**RE: Owl Place Commercial / Traffic Impact Study Addendum  
El Paso County, Colorado**

This traffic impact study addendum has been updated to address County review comments regarding auxiliary lane analysis, access point locations and site distance, future roadway classifications, roadway improvements, and various revisions throughout pursuant to the latest site plan.

**Site Distance Exhibit**

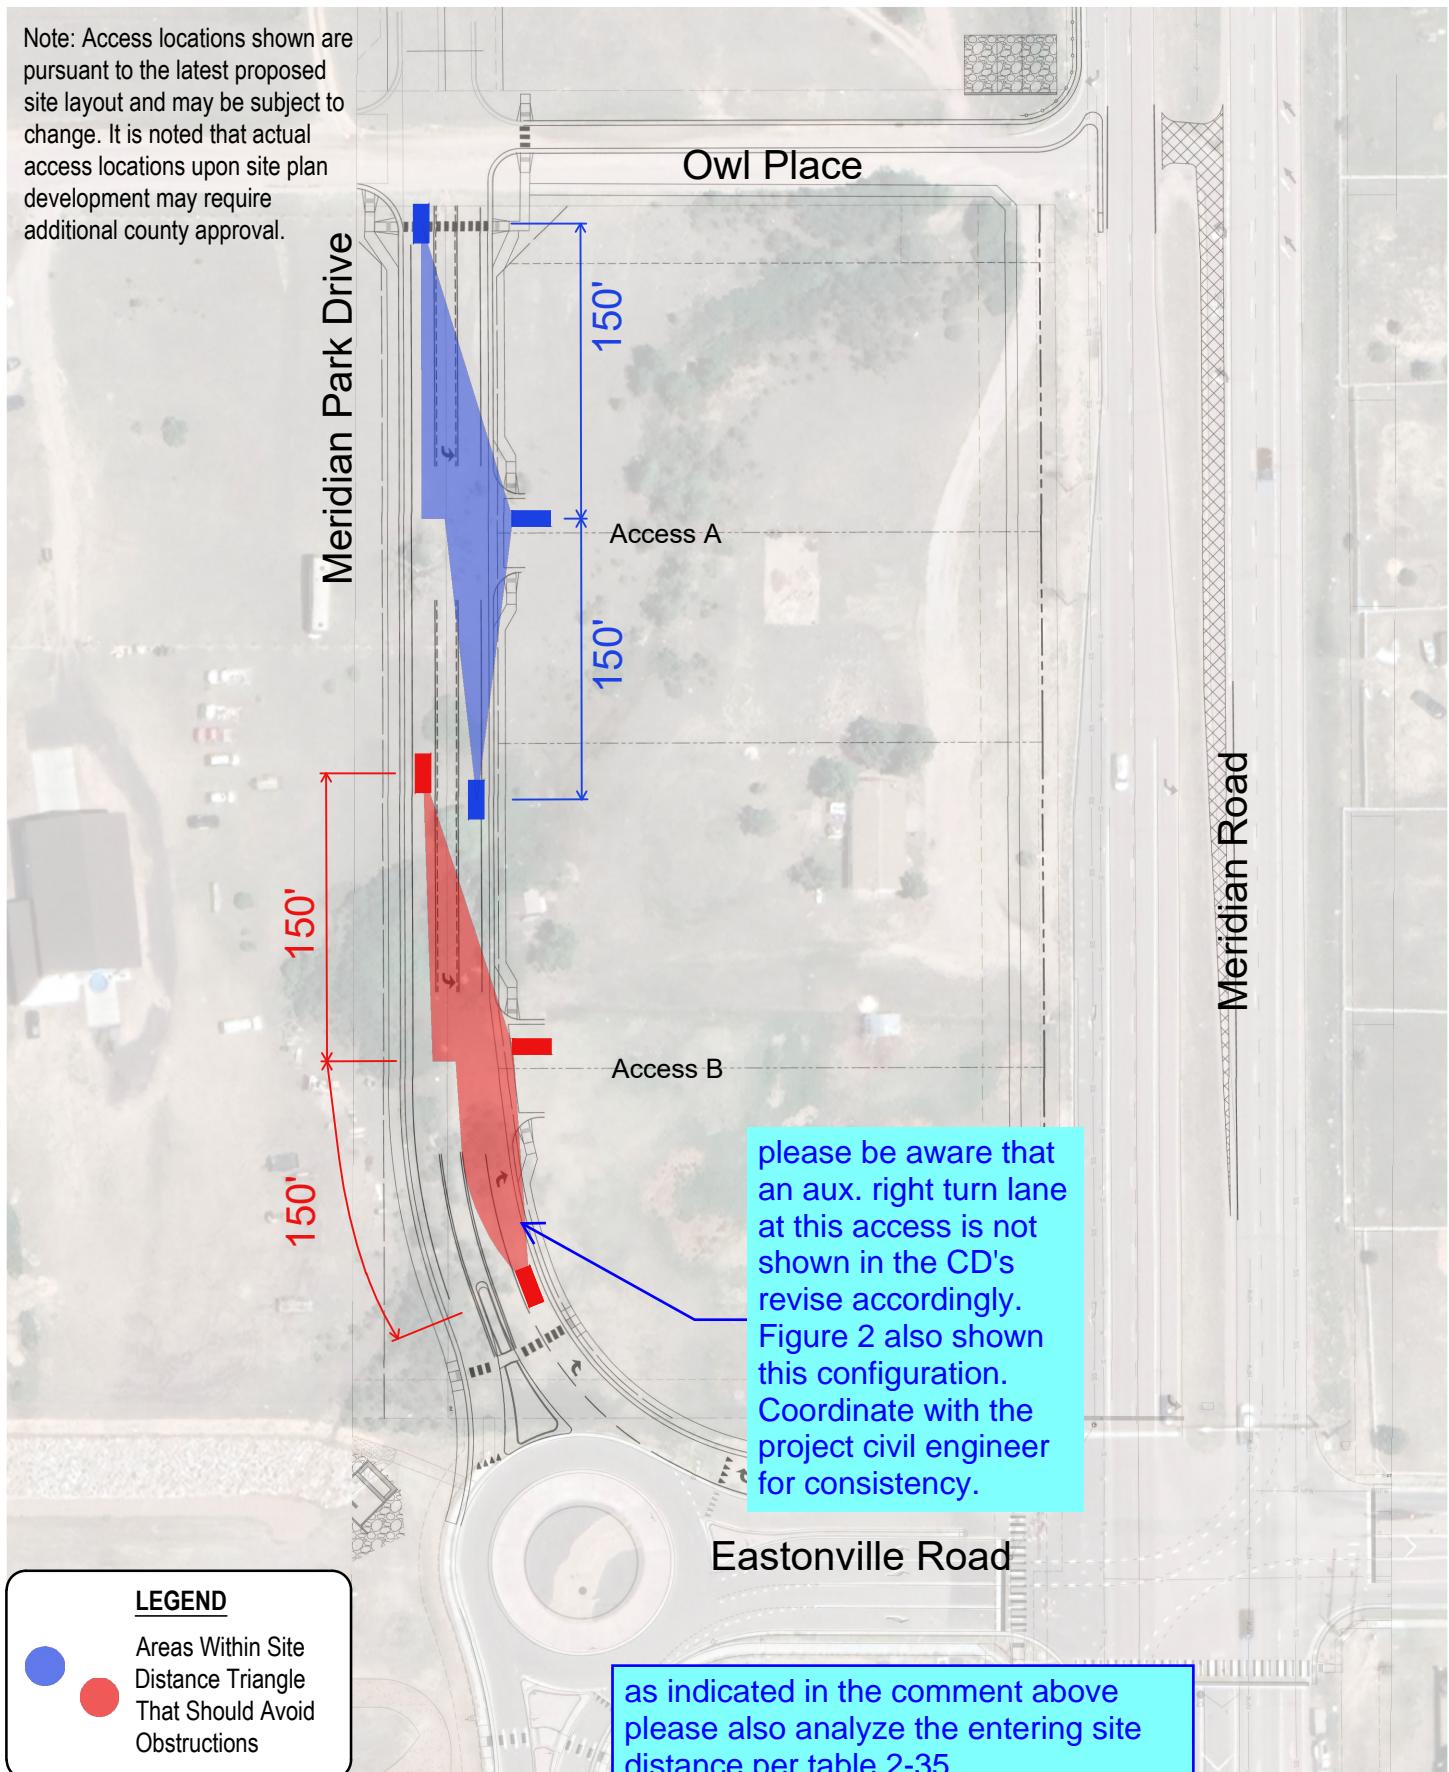
Please also include entering site distance analysis for the site access points per table 2-35

Review #2 comment indicated to analyze the two proposed access points per ECM 2.4:  
-Please refer to sight distance comments above and also address access spacing and clearance from intersection as indicated in ECM 2.4 A.
